**MOONEY AIRCRAFT, INC.**  
LOUIS SCHREINER FIELD • KERRVILLE, TEXAS

# Service Instruction

NUMBER: M20-24

SUBJECT: Change in clearance for Main Gear Shock Discs

**FIGURE 1 – LANDING GEAR SHOCK DISC INSPECTION DIAGRAM**  
**1962-'65 M20C INSTALLATION**  
**1963 & ON M20D INSTALLATION** (with constant speed propeller)  
**1964-'65 M20E INSTALLATION**

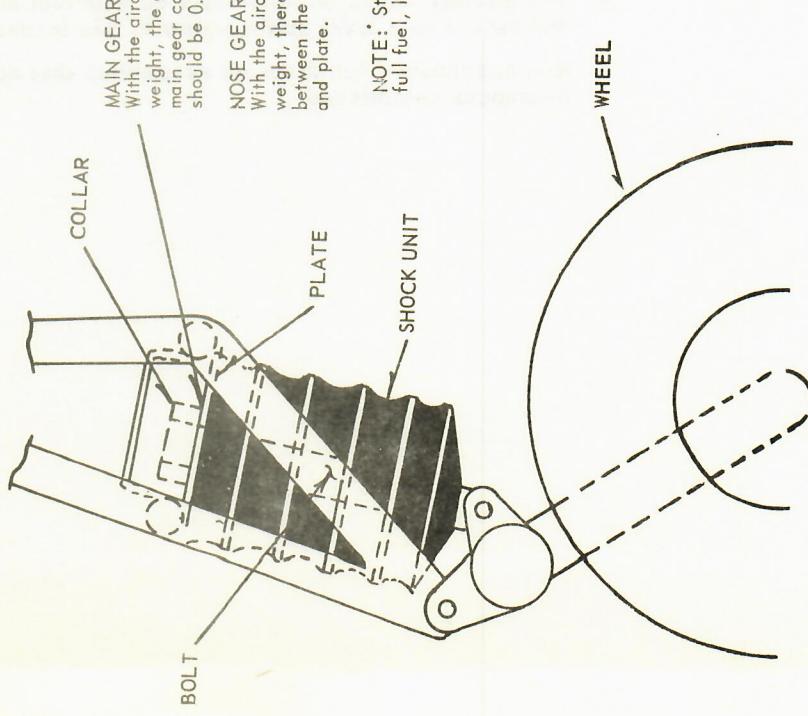
On Mooney M20 C, D (constant speed prop) & E type aircraft, an additional clearance at the main gear between the collar and the plate is allowed. (Fig. 1 & 2)

1. For 1966 Model M20 C & E with Lord Disc, P/N 530021, and those M20 C & E models retrofitted with Lord Discs, the maximum clearance between the 510049 collar and the plate on the main gear is 7/16 inches. (Fig. 2)
2. For those M20 C, D (constant speed propeller) & E with Firestone Discs, P/N 3CRE 714, installed, the maximum clearance between the 510027-8 or -9 collar and the plate on the main gear is 1/8 inches. (Fig. 1)
3. The clearance allowed between the collar and the plate at the nose gear remains zero.
4. The aircraft should be fully serviced with fuel and oil, cargo off-loaded and parked on a level surface prior to this inspection.
5. Replace those shock discs on assemblies that do not meet the clearance tolerances established.

**MAIN GEAR:**

With the aircraft at static weight, the gap between the main gear collar and plate should be 0.00 to 0.13 inches.

**NOSE GEAR:**

With the aircraft at static weight, there must be no gap between the nose gear collar and plate.
